On-site Review

Kansas State Fair

October 2004

(Final Report)

YE OLD MILL

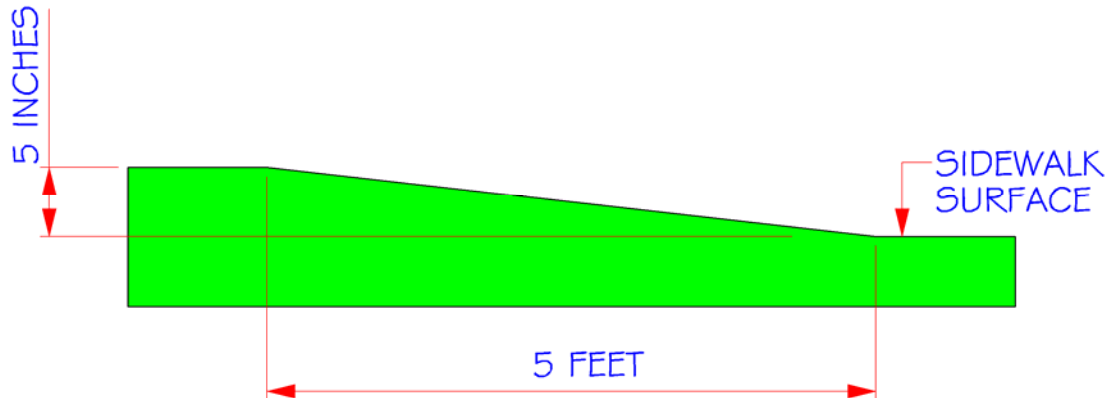
There is a 5 ½" step at the entrance of the ride. Patrons with mobility impairments are offered the use of a portable ramp. The ramp was not available for evaluation; it was being repaired. Modifications may be required for compliance. ADA, Inc. could not determine whether the portable ramp complies with the requirements of the ADAAG. Modifications are required for compliance.

There is no transfer system available at the Fair that would allow a person using a wheelchair to transfer from their wheelchair into and out of a boat without assistance.

The boats do not have wheelchair seating locations. The ride operators said that they do not believe that the boats would support the weight of a person in a motorized wheelchair without sinking the boat.

- The portable ramp must have a maximum slope of 1:12. For every one inch of rise, there must be at least one foot of horizontal run. The transition from the ramp surface to the ride area must be smooth and without abrupt changes.

- Install signage informing Fair patrons that a portable ramp is available upon request. The signage should be located at the entrance to the waiting line.
- It may not be feasible to provide wheelchair seating in a boat for this ride.

ENTRANCE

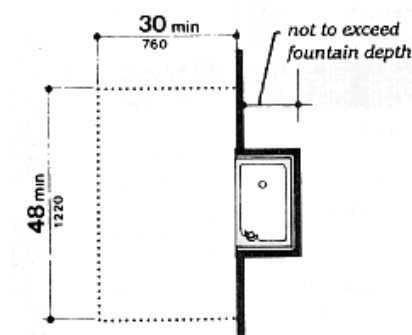
Exterior power-assisted door opener is blocked by chairs.

Carnival Midway

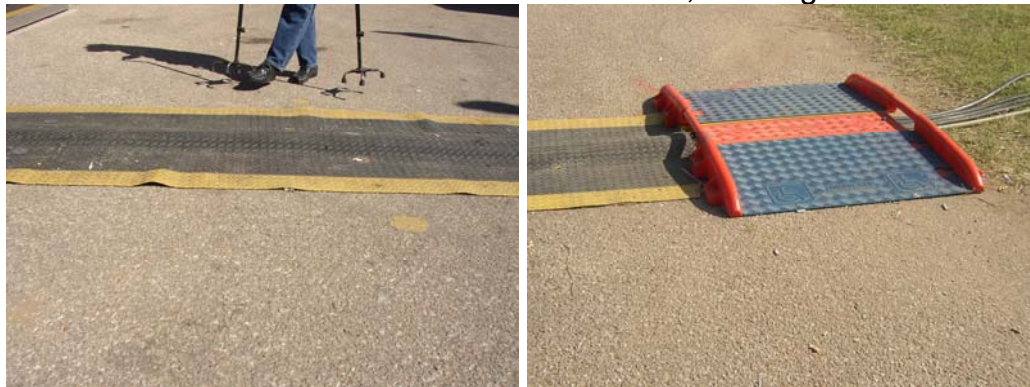
There is no accessible route along the full length of the Midway. The electrical cables that cross the Midway create a change in level of 1" or more. An accessible route cannot have any change in level greater than $\frac{1}{4}$ ".

Farrow Shows has made a clear effort to address the problem. They put heavy rubberized mats down over cables in some locations. They also provided several "bridges" over the cables. Unfortunately, there were not enough bridges or mats. The mats are insufficient as a solution; a change in level still remains.

- ❑ Require Farrow Shows to provide enough bridges to provide at least one to place over each set of cables that cross the Midway.

Tram

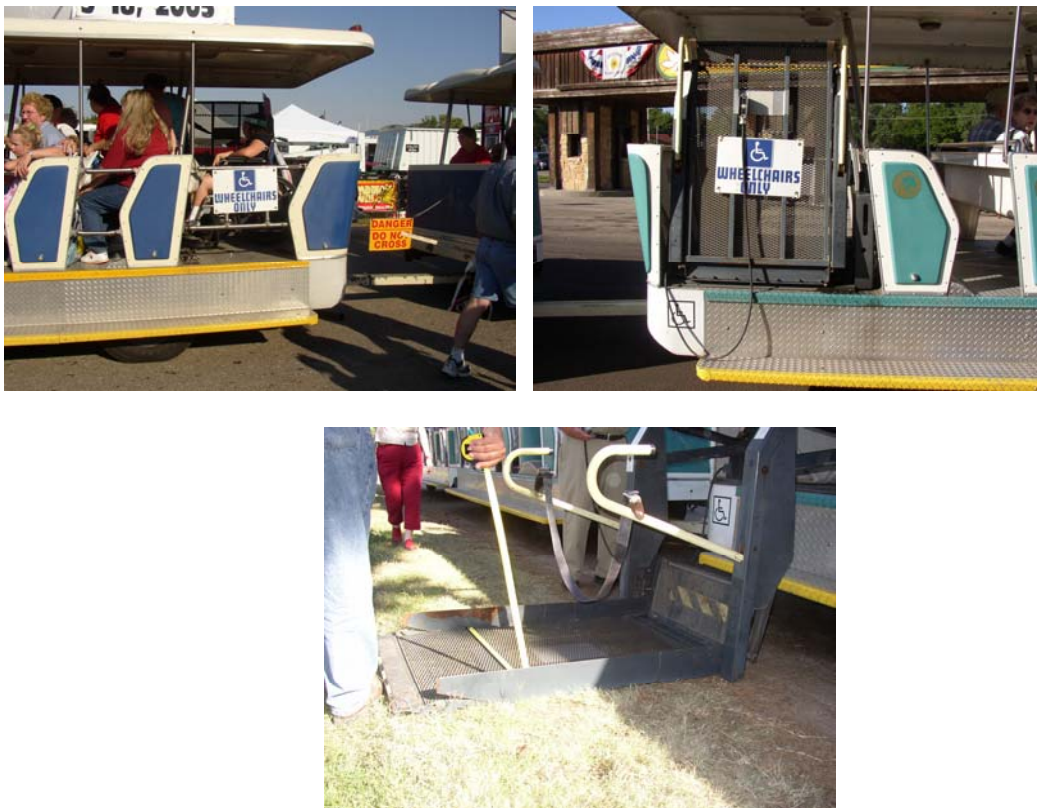
There is a People Mover at the Fair. The design specifications of the lift were not available at the time of the ADA, Inc. evaluation. The lift had the appropriate platform barriers. The lift was in apparently good working order and was seen in use by staff of ADA, Inc. The securement system was in good working order and permitted a wheelchair user to sit facing forward.

No modifications are required for compliance.

E-9 Entrance

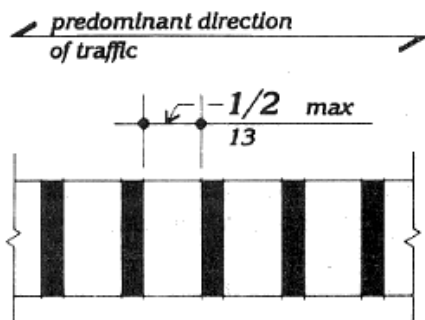
There is a grate at the E-9 entrance located in the walking surface and directly in the path of travel to the entrance. The openings of the grate are $7/8$ " wide, and located parallel to the path of travel.

There is an accessible route for people with disabilities coming from the parking lot to the E-9 entrance. However, patrons who use wheelchairs must leave the area protected by a barricade, which include curb ramps, and travel outside the barricade while being exposed to the vehicle traffic coming into the parking lot.

- ❑ Replace the grate with one that has openings no greater than $\frac{1}{2}$ " wide in one direction. Grates with elongated openings must be placed so that the long dimension is perpendicular to the path of travel (Section 4.5.4). See figure below.
